ITEM NUMBER	5.2
SUBJECT	Planning Proposal for land at 10 Valentine Avenue, Parramatta
REFERENCE	RZ/6/2018 - D06207941
REPORT OF	Project Officer-Land Use Planning
LAND OWNER:	Australian Unity Investment Management Administration Pty. Ltd.
APPLICANT:	Investa Office Developments

This report requests the Local Planning Panel recommend to Council that it endorse a Planning Proposal for the land at 10 Valentine Avenue, Parramatta and that the Planning Proposal be forwarded to the Department of Planning and Environment for a Gateway Determination. The report also requests the Panel recommend to Council that it endorse the preparation of a site-specific Development Control Plan to manage the built form and public domain in association with the Planning Proposal.

Figure 10: Applicant's Urban Design concept (Reference design 2) east-west section
(Source: Applicant's Urban Design report, Fitzpatrick + Partners)

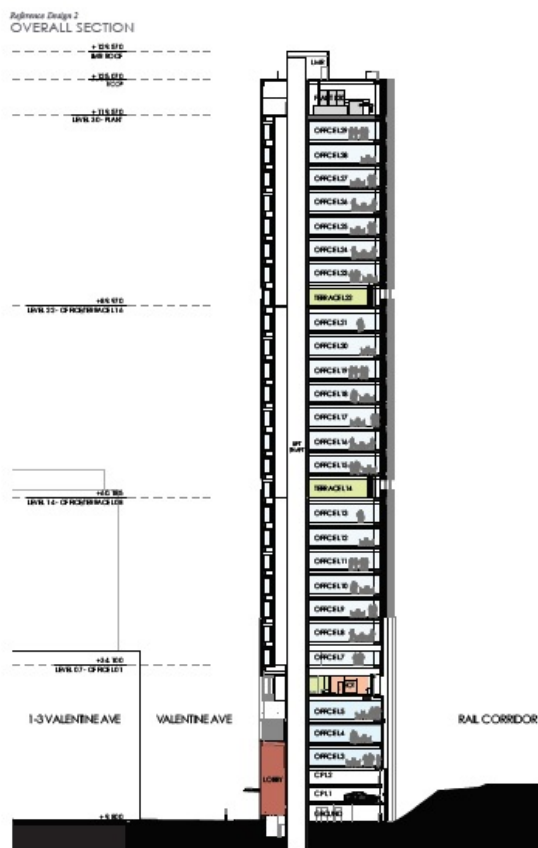
22. The difference between Reference Design 1 and Reference Design 2 relates to the land uses within the podium. The podium for Reference Design 1 consists of 6 levels of aboveground car parking. The podium for Reference Design 2 consists of 3 levels of aboveground car parking and 3 levels of office space.
23. A table summarising the car parking spaces under different scenarios is provided in Table 2 below.

28. With regard to the reference design, concerns were raised with the initial reference design submitted with the Planning Proposal. Council's City Architect's team noted that during the course of the assessment of the development application which followed the Design Competition (DA/841/2017) a negotiated position was reached on the following:

29. The applicant's Urban Design Report references the DCP podium height control (26 metres above natural ground) as being the relevant benchmark for their site. However, the primary concern with the podium height is the nature of the podium itself which contains car parking. The Parramatta DCP 2011 seeks to avoid aboveground car parking in the CBD where possible. Where basement car parking is not possible, the aboveground car parking should be sleeved with other uses (ie in this case commercial floor space) to avoid blank walls being presented to the street..

31. Given these constraints, it is considered acceptable in this case, for car parking to be provided in the podium. However, the visual impacts of this need to be managed appropriately and minimised. For this reason, the assessment of the development application reached a position where the overall podium height was limited to that of the existing concrete car parking structure (25.0m AHD). This resulted in 6 levels of aboveground car parking in total.

32. No objection is raised to the revised reference designs (Reference Design 1 and Reference Design 2). It is noted that if a new development application is lodged in the future that has no relationship to the original consent, a new design competition will be required. As such, it is appropriate to prepare a site-specific DCP to accompany the Planning Proposal that prescribes a maximum podium height of 25.0m AHD as identified through the assessment of the previous development application.

- a. The inclusion of a site-specific clause within PLEP 2011 that applies the maximum car parking rates endorsed by Council as part of the Parramatta CBD Planning Proposal.
- b. The inclusion of a site-specific DCP which sets a maximum podium height at 25.0m AHD. The DCP should also require the footpath design to be capable of being narrowed if Valentine Avenue is converted to two-way traffic in the future.
